AGENDA

President and Board of Trustees
Village of Arlington Heights
Board Room

November 6, 2017

PC Project Number: PC 16-012
Project Title: Ivy Hotel
Address: 519 W. Algonquin Rd.
PIN: 08-16-103-008, 08-16-103-009

SHEET 3 OF 5

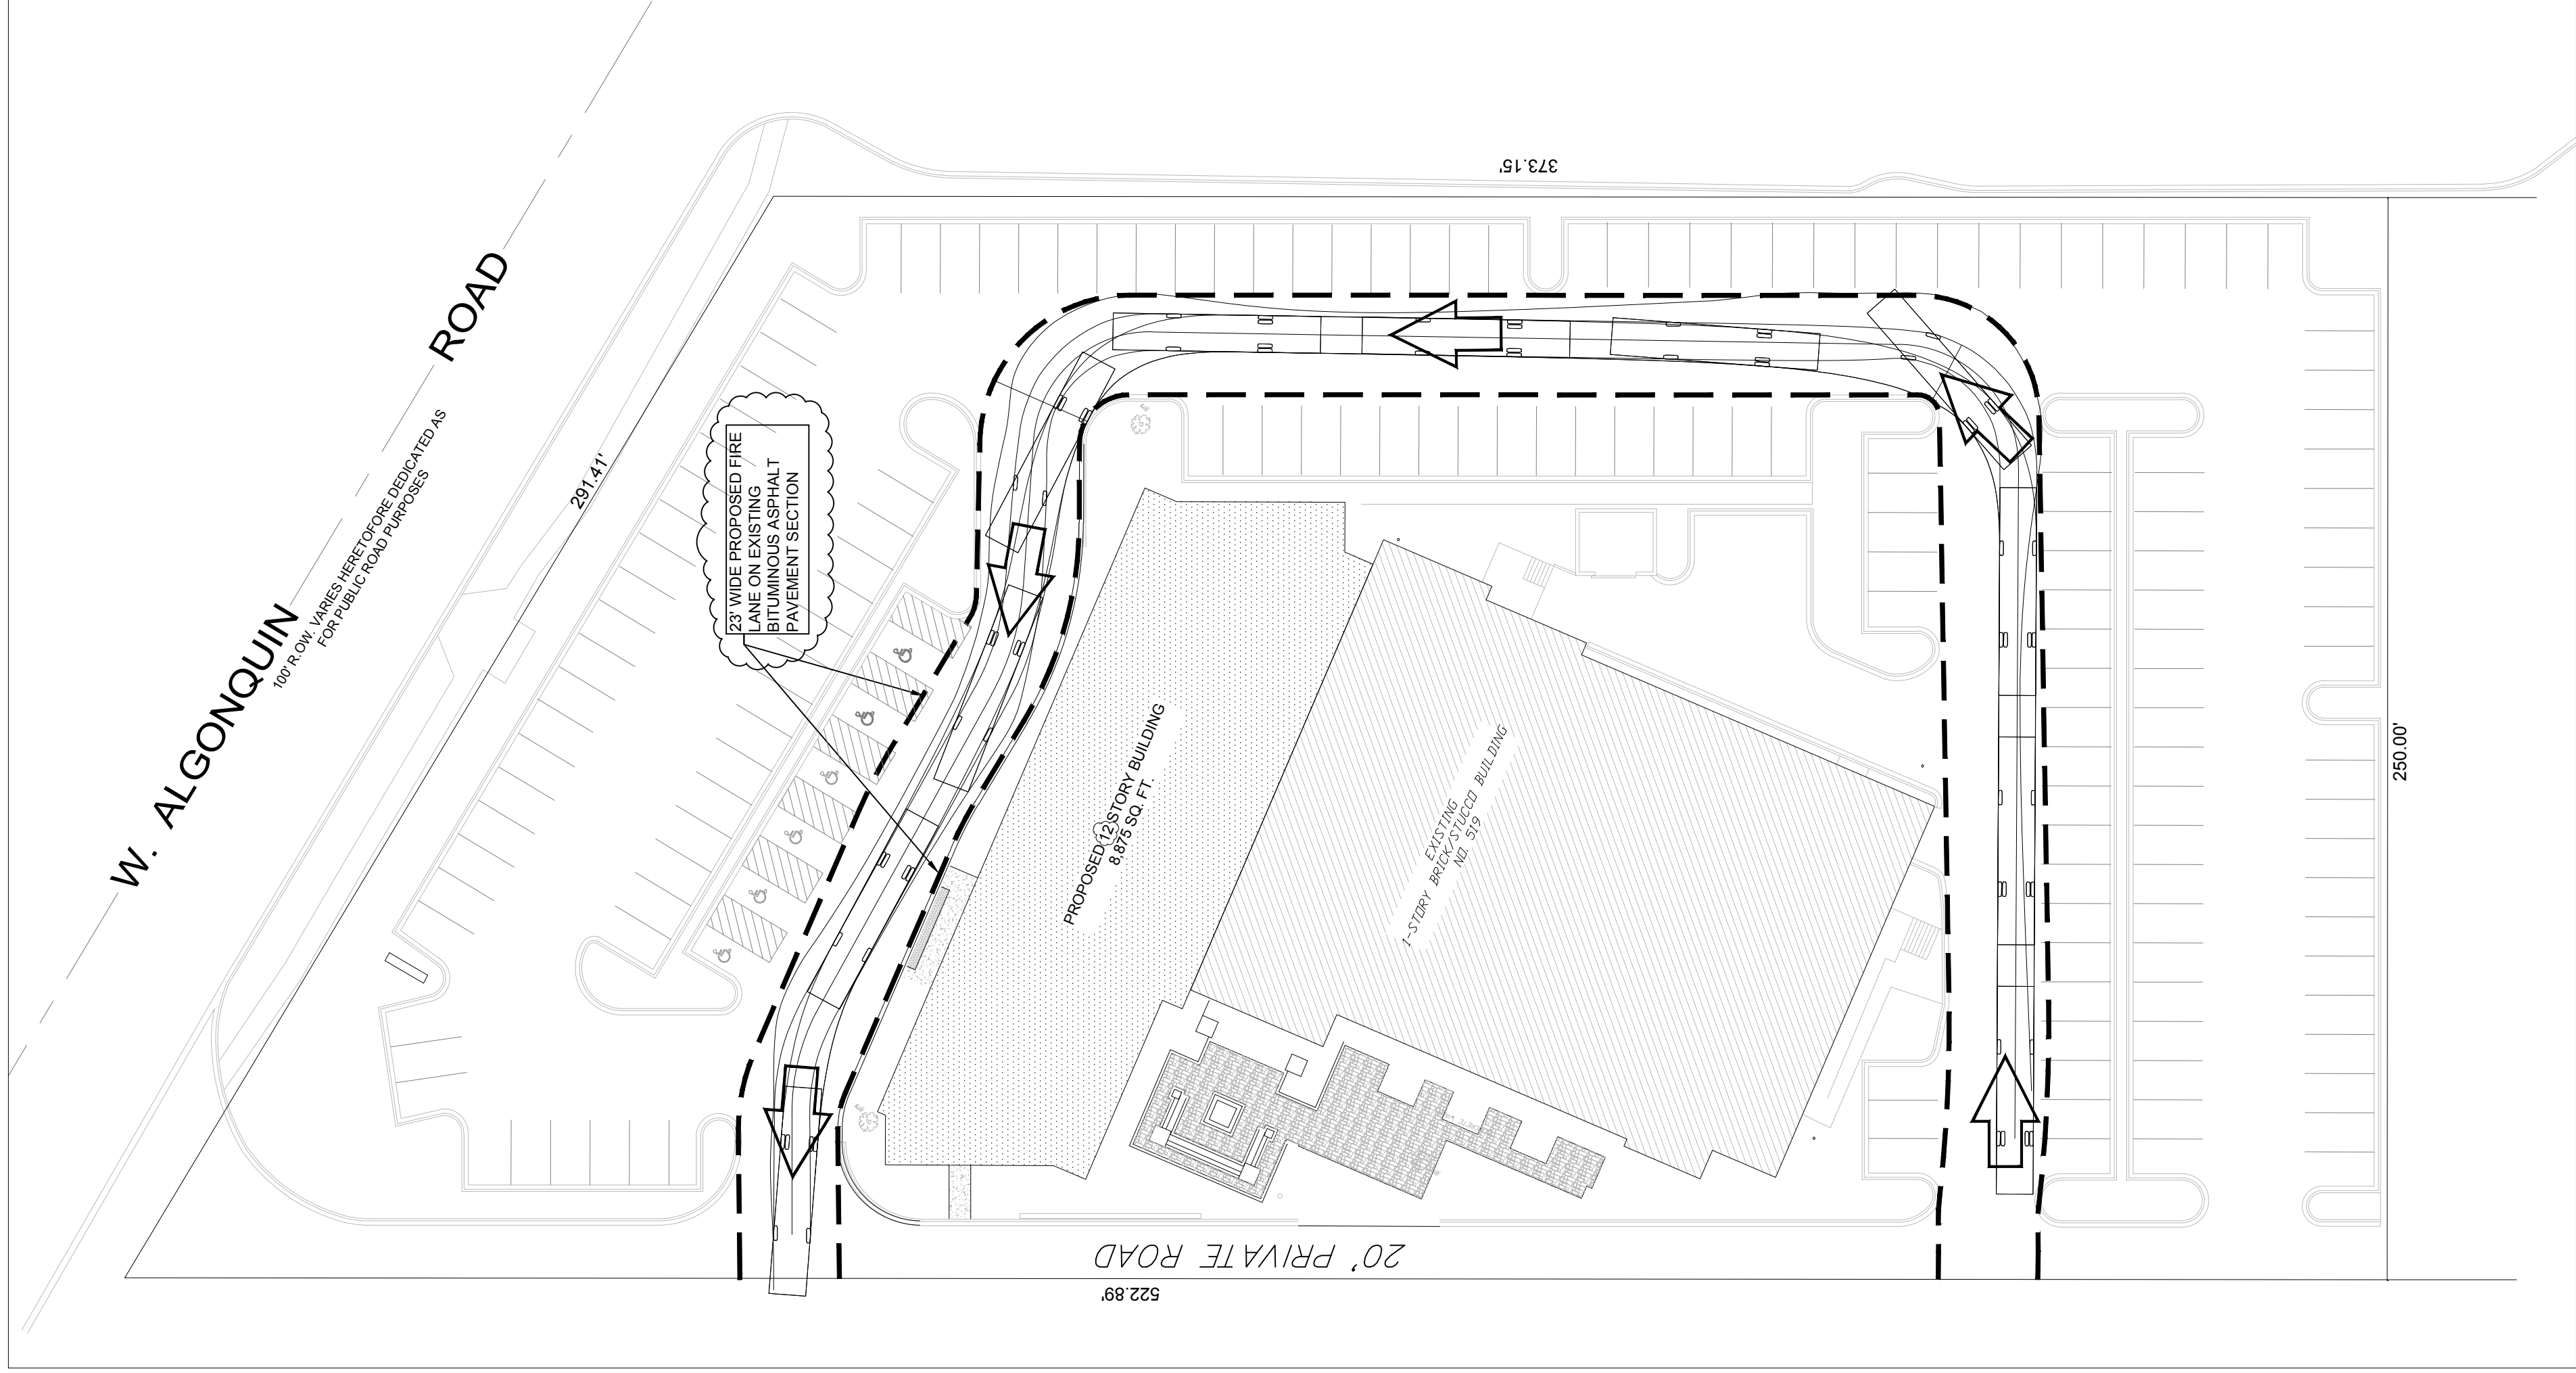
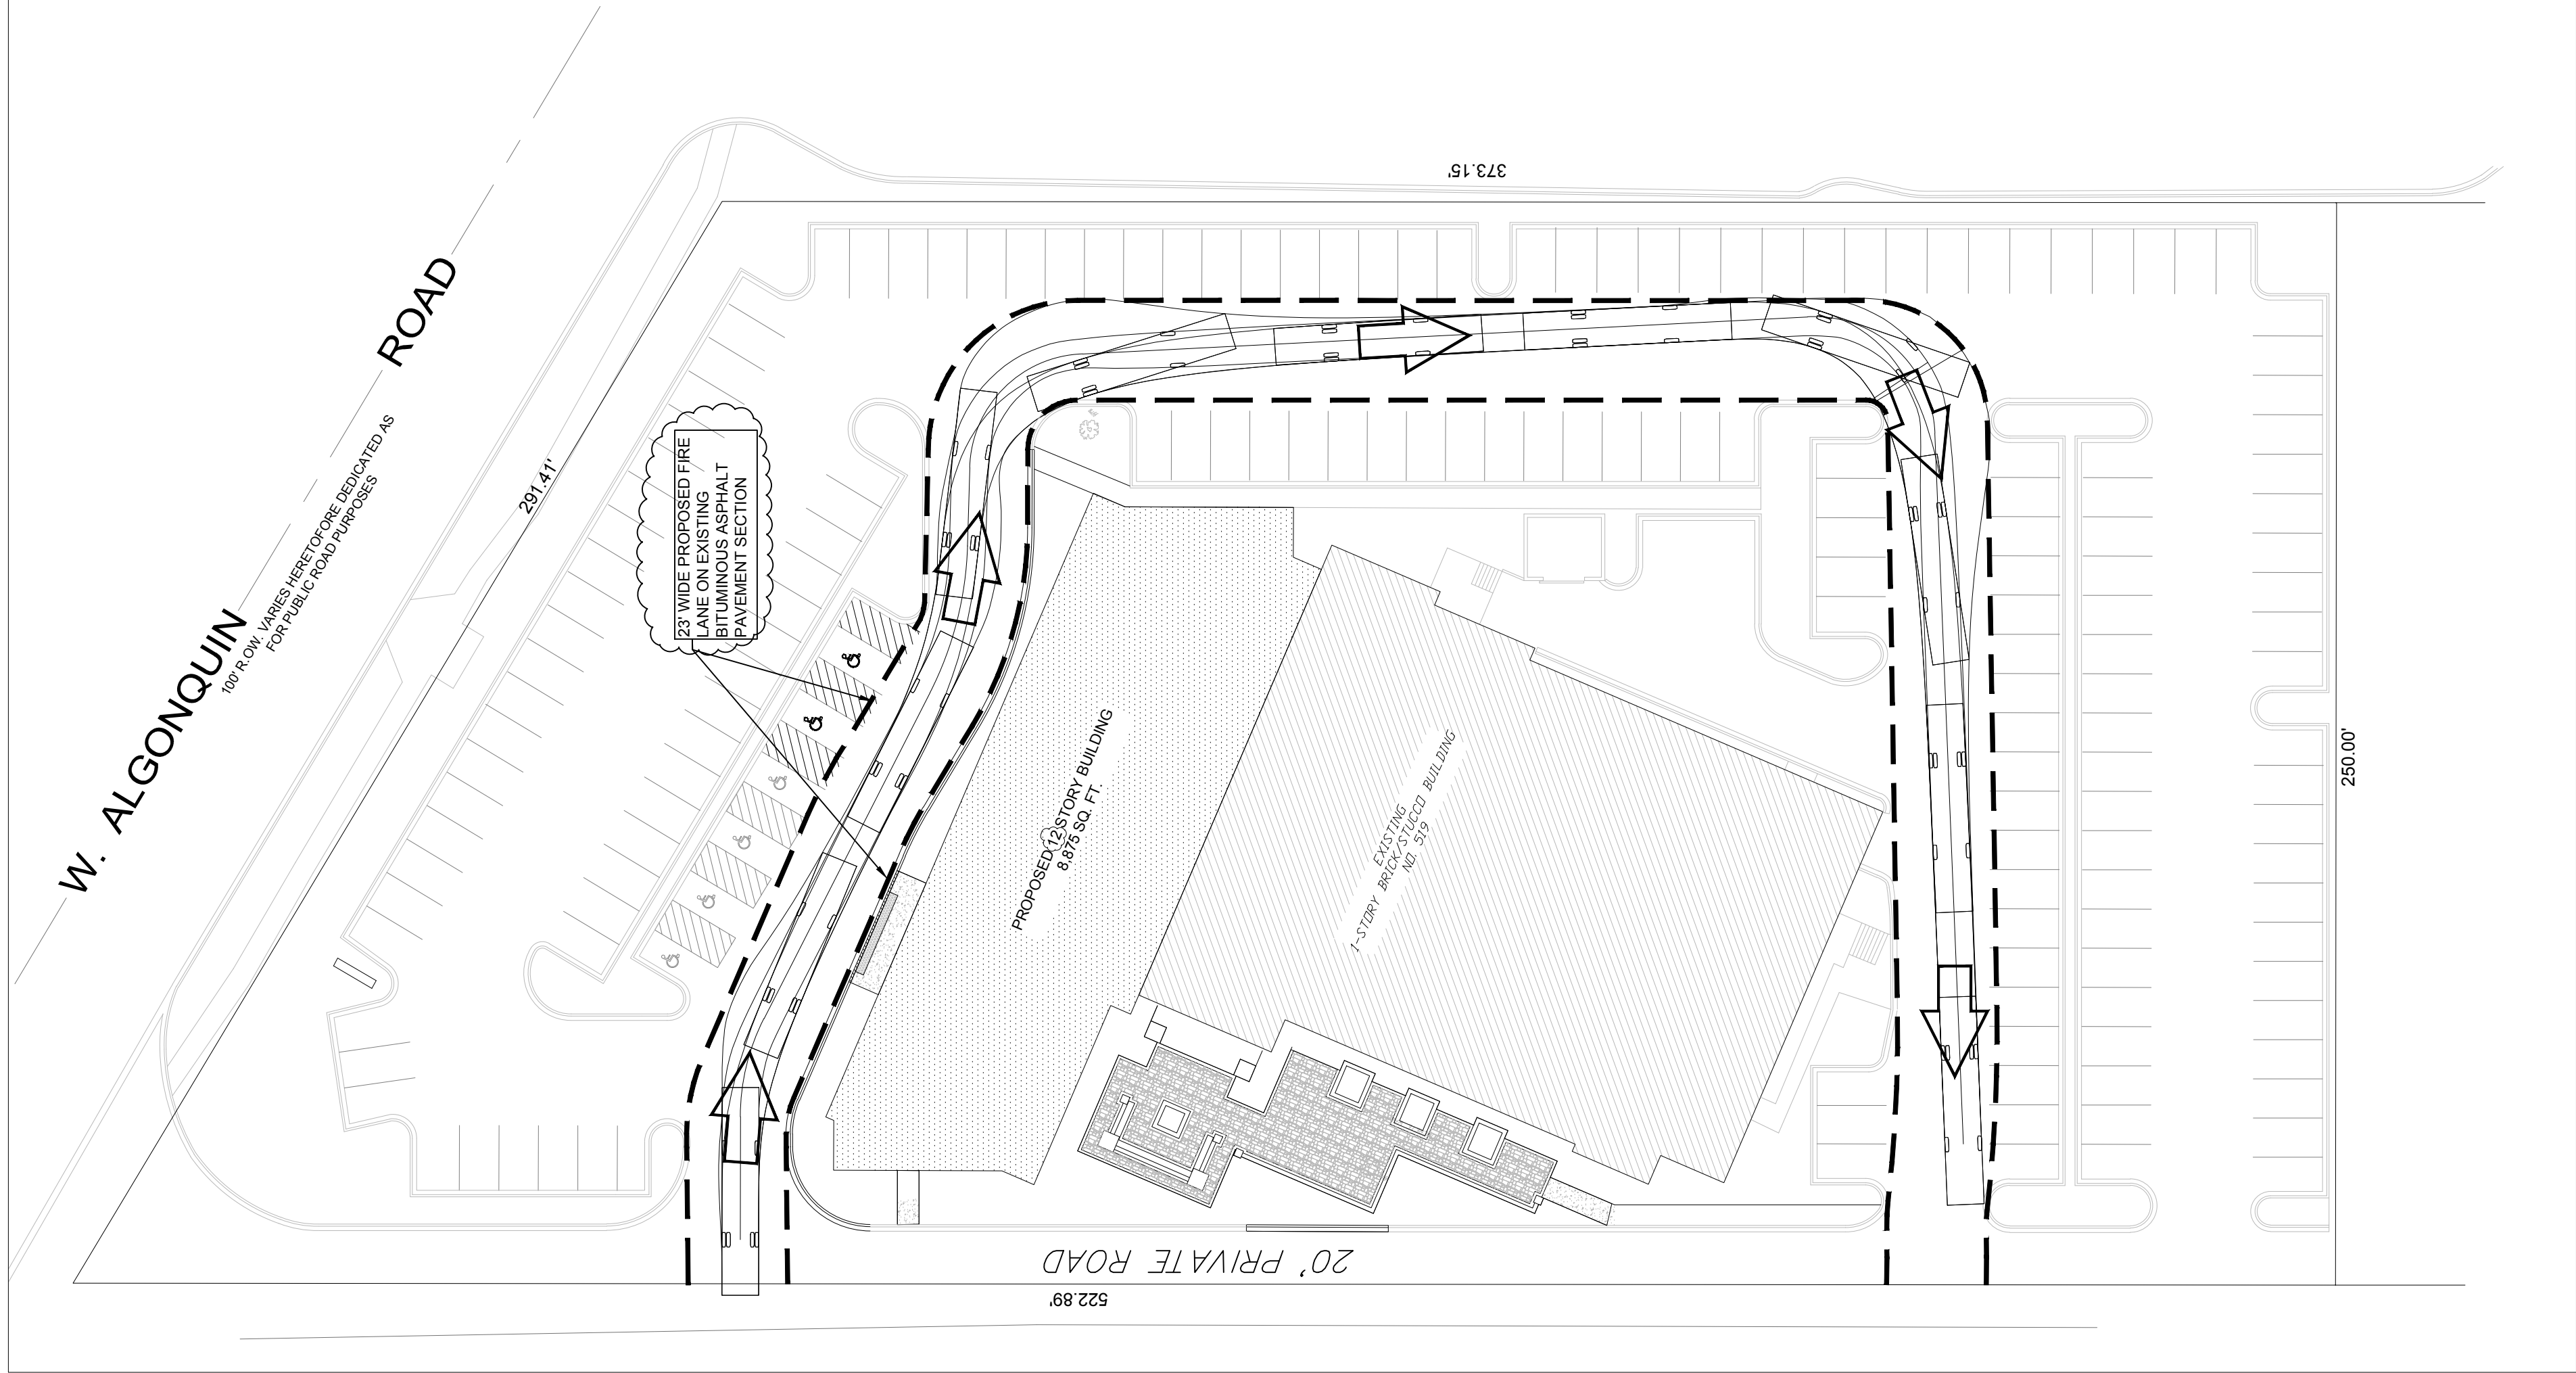
- 1) What is the purpose of the proposed 6" pressure connection and new fire and domestic water line into the proposed new building (Ridgeline Consultants drawing 3 of 5)? This is a new water service.
- 2) After the new fire and domestic service is installed, the old "original" service to the banquet hall needs to be abandoned and reconnected to the new service. **One service for one customer.**
- 3) A new 6" compound meter is required.
- 4) The new RPZ's for domestic and fire protection will be sized once flow calculations by the designer have been completed.

Truck Turning Exhibit

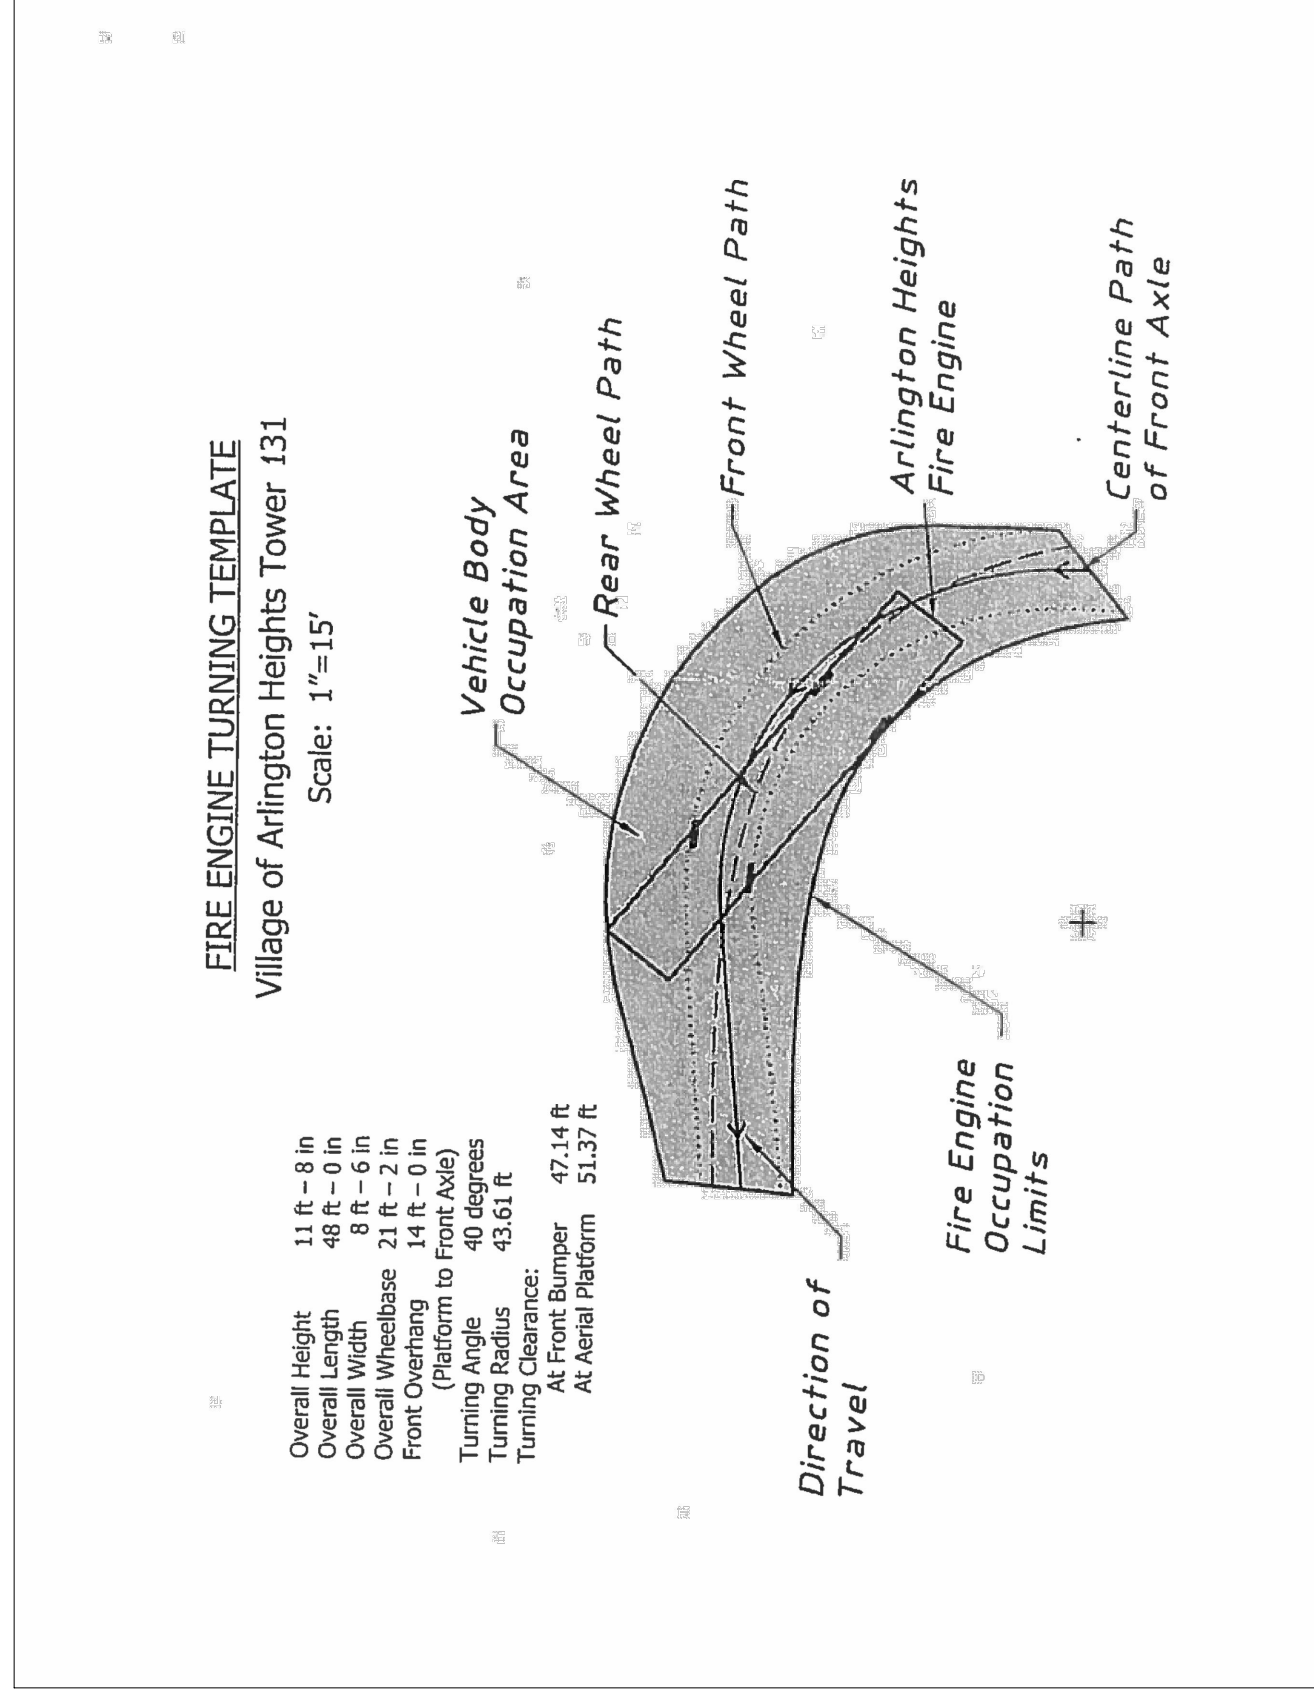
15. Any under pavement stormwater facilities must be designed to handle AASHTO HS-25 loading.
16. The exhibit on Sheet 6 showing the responding vehicle turning path labels the truck as "Itasca Fire Truck 2". Use the enclosed attachment for the Village of Arlington Heights's responding vehicle.
